Date: December 2, 2021 Job No.: 4830
To: Mr. Gregory Rondeau, Chairman
Cc: Amy Love, Town Planner
From: Matt Crowley, PE
Subject: **5 Fisher Street Peer Review**

DATE: November 30, 2021
TO: Franklin Planning Board
FROM: Department of Planning and Community Development
RE: 3, 5, 7 Fisher Street
Site Plan

project title:
FACTORY SQUARE FRANKLIN

5 FISHER STREET, FRANKLIN, MA 02038

drawing title:
GRADING & UTILITIES

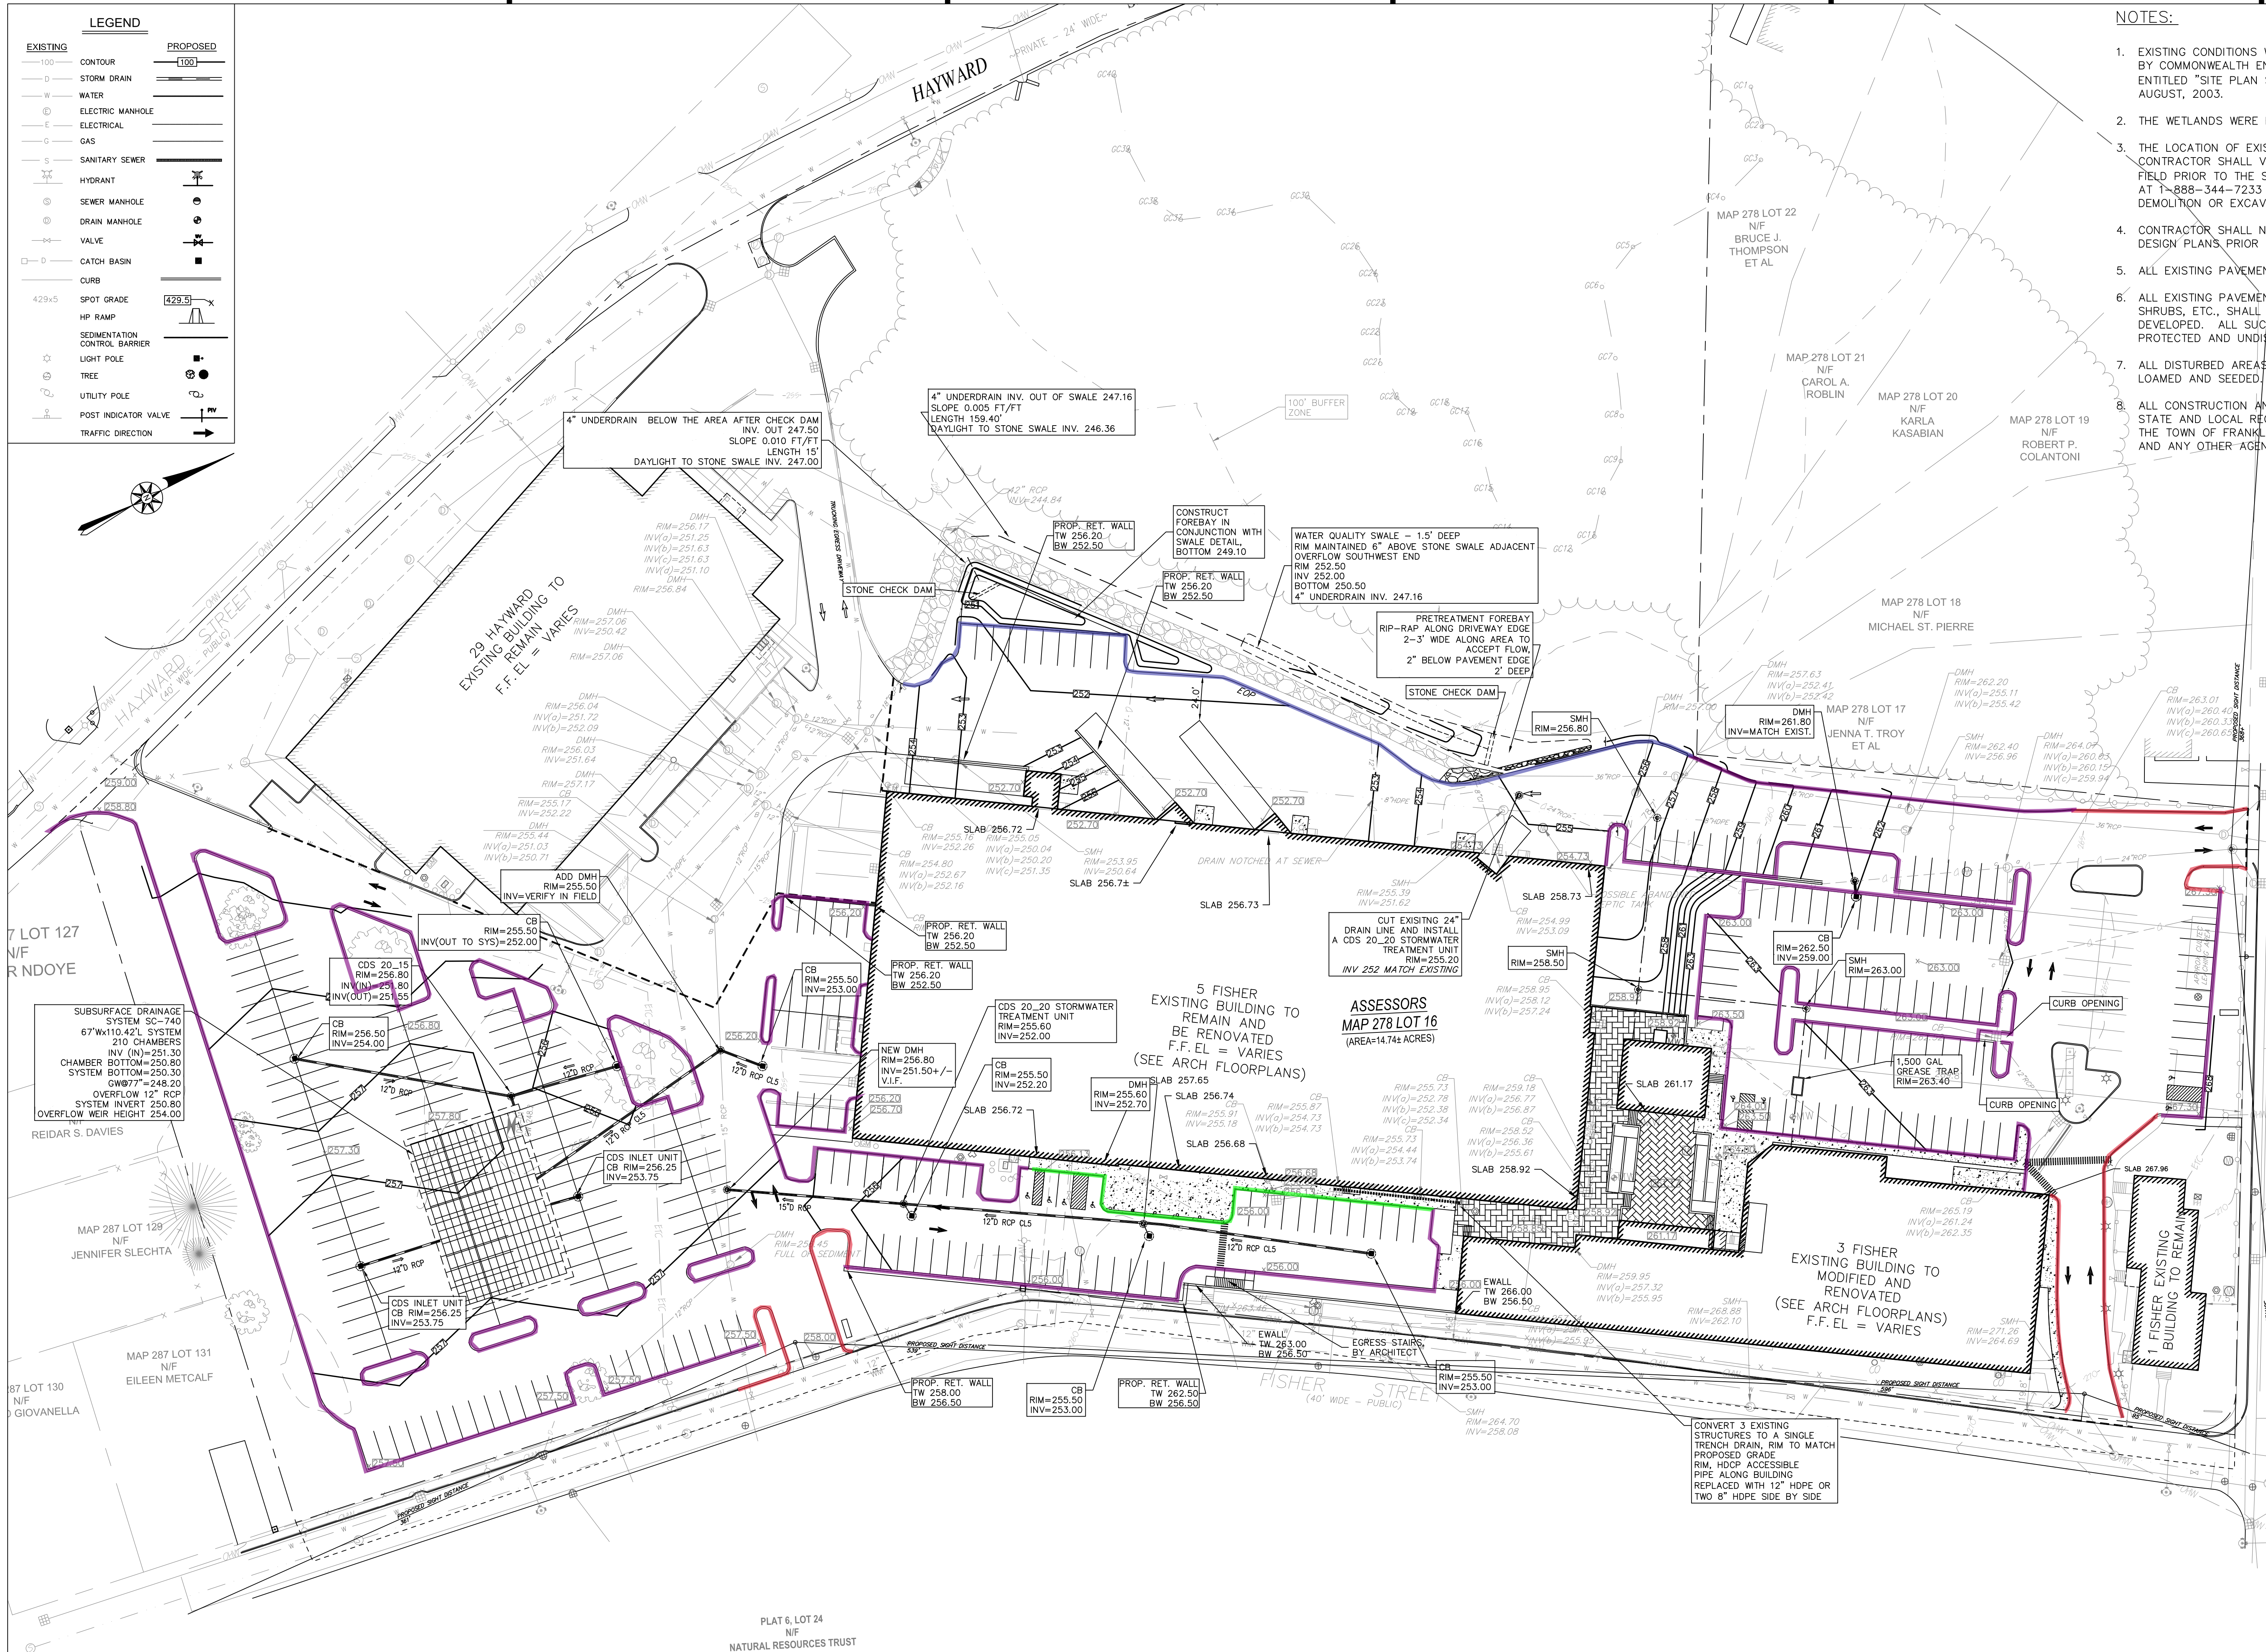
3. Planning Board asked about the handicap parking spaces. The Applicant has provided a narrative on the location of the handicap parking spaces. Also note, the Town's ADA Compliance officer will also monitor the handicap parking spaces.
4. Attached to this memo, is an email sent to DPCD from an abutter who was not able to speak at the last meeting.
5. BETA has provided a letter with recommendations for Condition of Approval.
6. Planning Board requested a plan detailing the type of curbing throughout the site. Applicant has provided a plan. Below are the color details:

Blue=No Curb

Red=Granite

Purple=Precast Concrete (reinforced)

Green=Haunched concrete(poured with sidewalk)

No color=existing
